## Garrett Wade

## Technical Memo T21

Re: 23N02.01 23N02.02 23N02.10

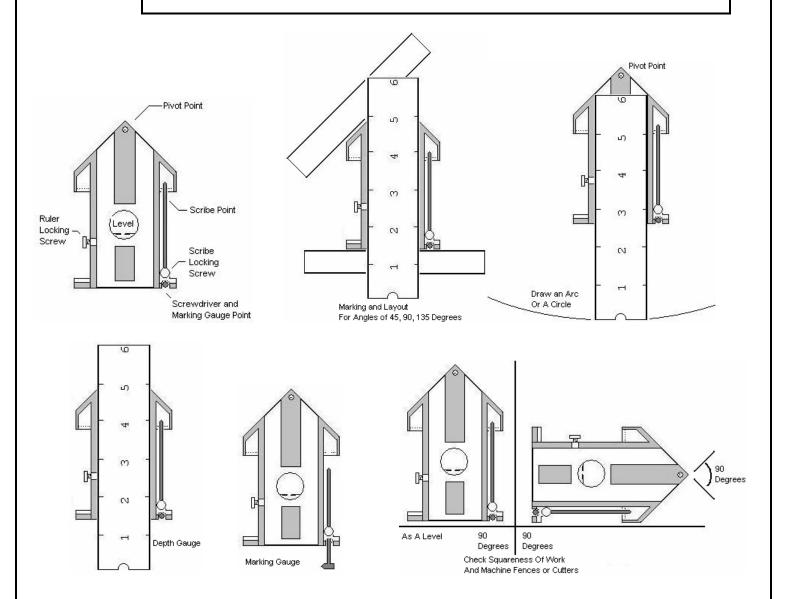
**Special Note:** Sometimes the screwdriver on the scribe does not fit the slot of the pivot screw. This can easily be corrected with a small file by removing any burrs left on the tip from the machining process. Simply filing the flats of the tip a few times will correct the problem.
